June 23, 2020
Case: HPC.ALT 2020-11
Site: 47 Vinal Avenue

ALTERATION OF A LOCAL HISTORIC DISTRICT PROPERTY
STAFF REPORT

Site: 47 Vinal Avenue
Historic Name: Lizzie Wellington House

Petition: *Replace basement windows with egress windows and replace bulkhead doors*

ELEVATION- EAST (FRONT
ENTRY)

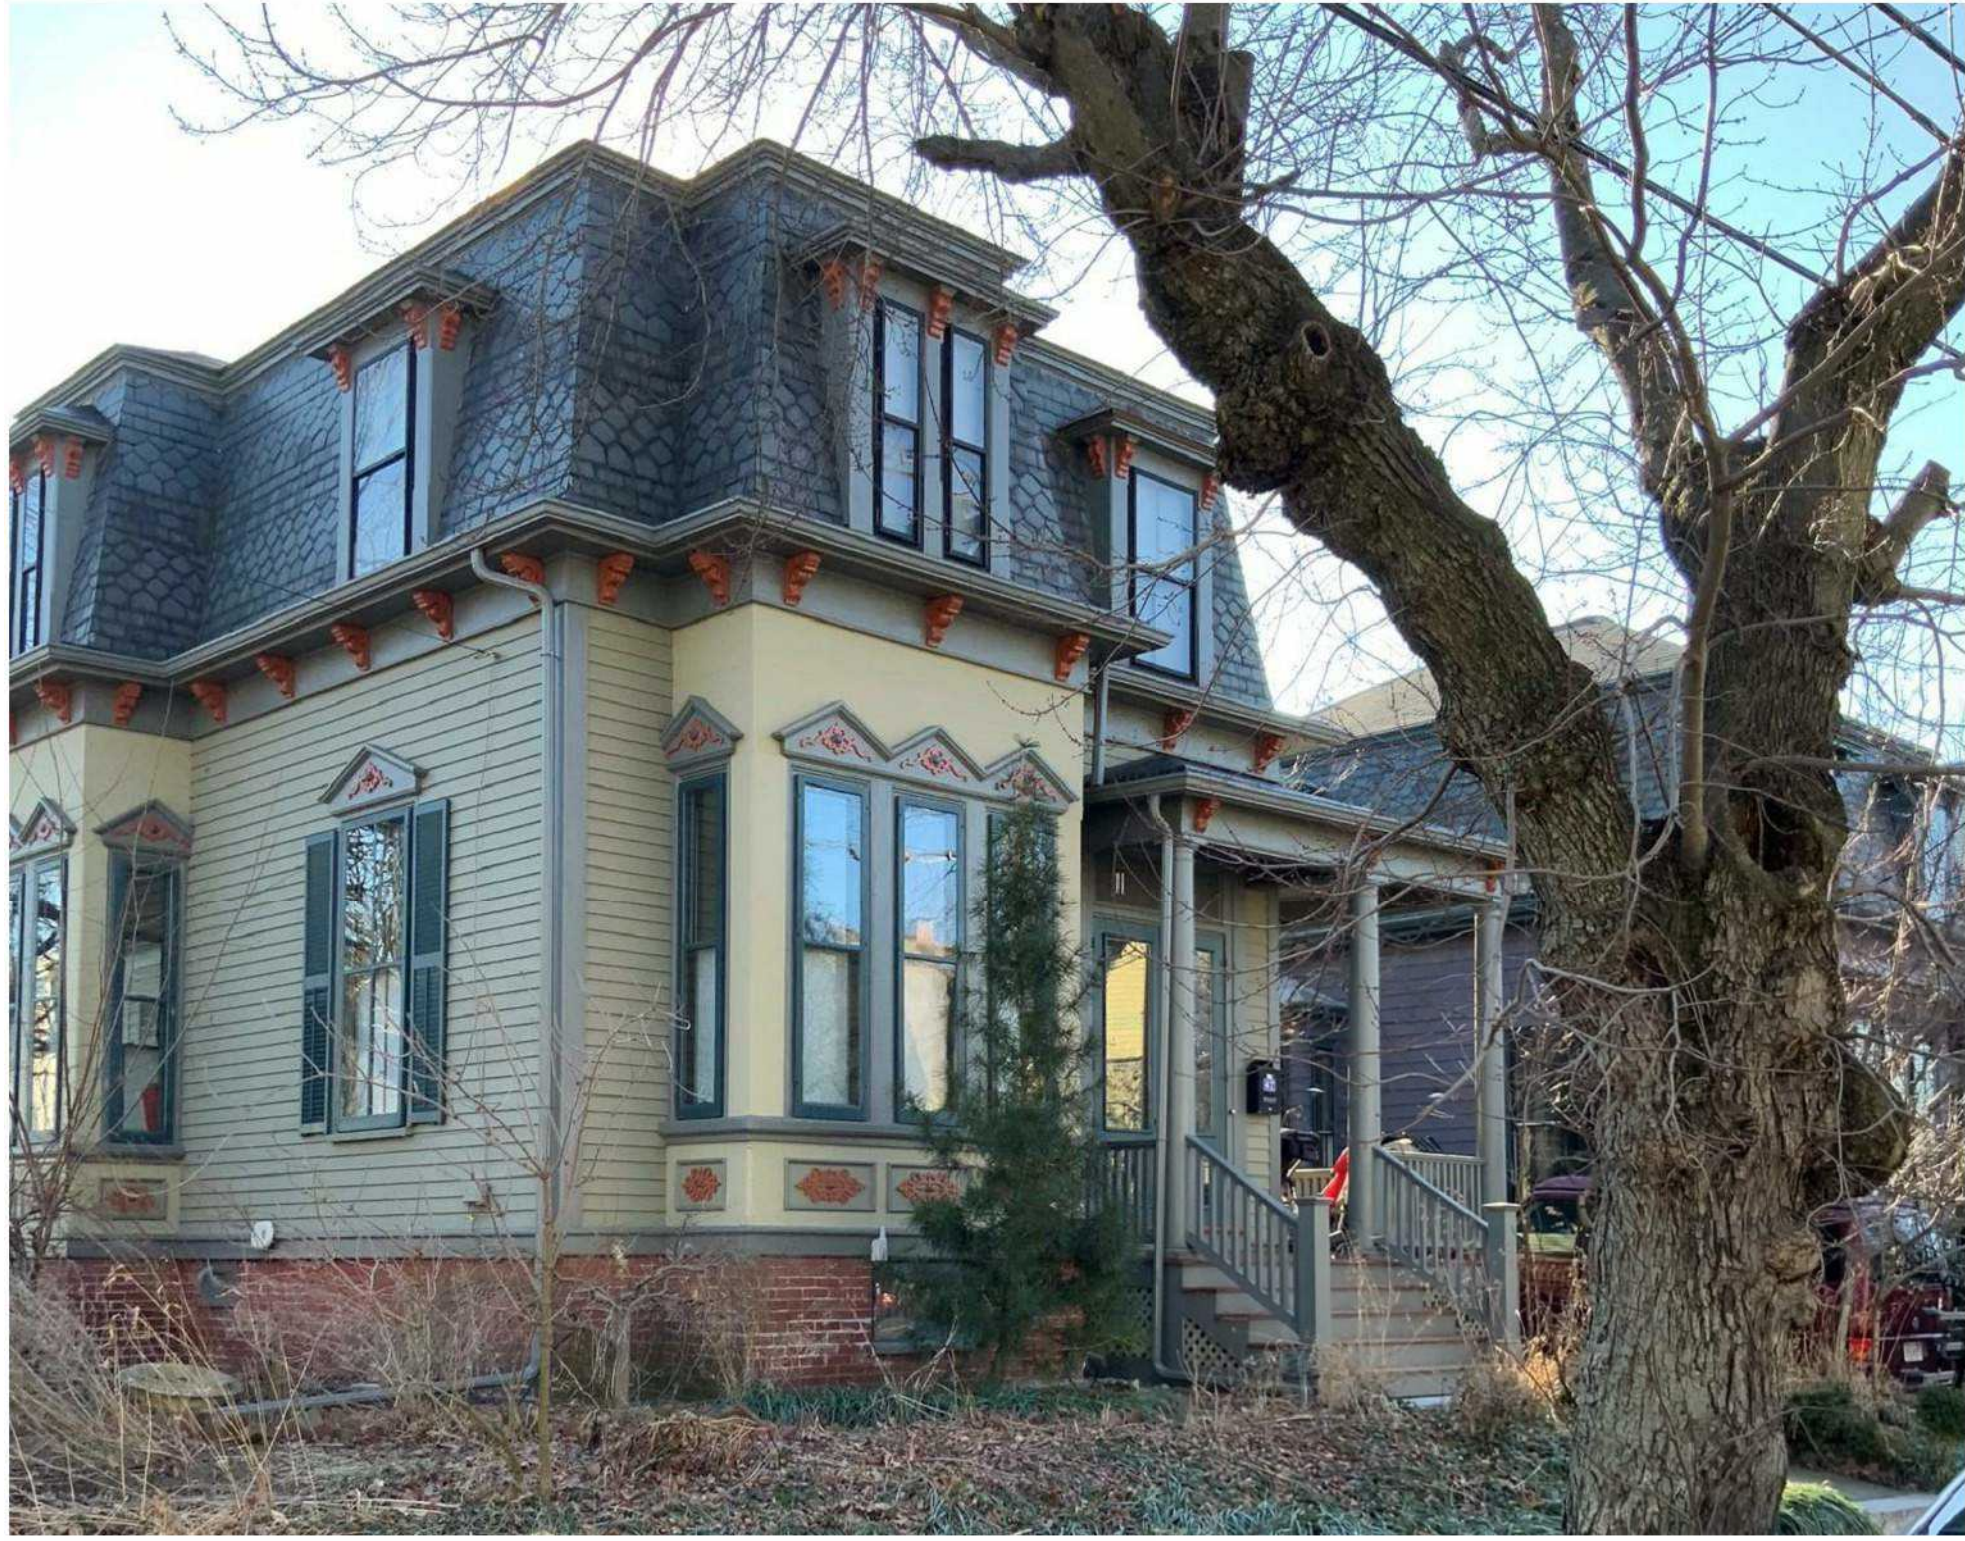
The openings for these egress windows will be in the same location as the current basement windows, the openings will just be larger. While these new windows will be visible from the public ways of Vinal and Pleasant Avenues, roughly 50% of each window will be below grade as they are to open into a sub-grade window well.

The Applicant acknowledges that it is unclear at this time if or how much of the window well structure will be visible above grade. Staff has added a condition to address this issue in terms of materials used.

1. Any building permits needed to install the ductless AC system shall be obtained from ISD prior to the start of work.
2. Egress windows shall present a matte/baked finish. Egress windows shall not be tinted or present a mirror-like quality.
3. Should the window wells protrude above grade, the above-grade material shall be capped brick as shown in the plan renderings. The brick shall match that of the main structure’s foundation in size and color. Mortar joints shall be the same size as those found in the foundation of the main structure.
4. Any changes to the proposal are subject to the review and approval of the HPC prior to execution.
5. The Applicant shall contact Preservation Planning at historic@somervillema.gov a minimum of 15 business days prior to final inspection so that they or their designee can confirm that the project was completed according to HPC approvals.
